Access Compliance Report Public Rights-of-Way (Curb Ramps)

Intersection ID: 17696Main Street:DENON_HILLS_DRCross Street:E W T HARRIS BVLocation:SWADA ID: BA30C66A89B9Ramp Type:PerpDiagInitial Pass/Fail:FailOverall Compliance:NoSeverity Score:21.25

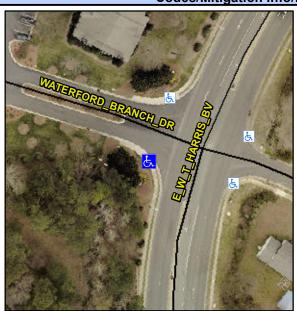
Not Found, R304.5.1, R304.2.2

Field Measurements/Component Compliance					
Compliance Description		Data	Comp	liance Description	Data
N/A	Ramp Length (in)	27.5	No	Ramp Slope (%)	8.4
No	Ramp Width (in)	46.5	Yes	Ramp XSlope (%)	0.2
N/A	Flare Type LT	N/A	N/A	Flare Type RT	N/A
N/A	Flare Slope LT (%)	N/A	N/A	Flare Slope RT (%)	N/A
N/A	Flare Traversable LT?	N/A	N/A	Flare Traversable RT?	N/A
N/A	Landing Length (in)	N/A	N/A	DWS Provided?	N/A
N/A	Landing Width (in)	N/A	N/A	DWS Contrast?	N/A
N/A	Landing Slope (%)	N/A	N/A	DWS Length (in)	N/A
N/A	Landing X Slope (%)	N/A	N/A	DWS Full Width?	N/A
N/A	Landing Curb? (Y/N)	N/A	N/A	DWS Offset (in)	N/A
N/A	Shared Landing?	N/A			
N/A	Gutter Ponding?	N/A	N/A	Gutter Slope (%)	N/A
N/A	Gutter Lip Ht (in)	N/A	N/A	Gutter X Slope (%)	N/A
N/A	Painted X Walk1?	No	N/A	Painted X Walk2?	No
	X Walk 1 Direction	To SE		X Walk 2 Direction	To NE
N/A	X Walk 1 Width (in)	N/A	N/A	X Walk 2 Width (in)	N/A
	X Walk 1 Slope (%)	0.4		X Walk 2 Slope (%)	2.1

Remove & Replace Curb Ramp With Two New Directional Ramps or Equivalent.
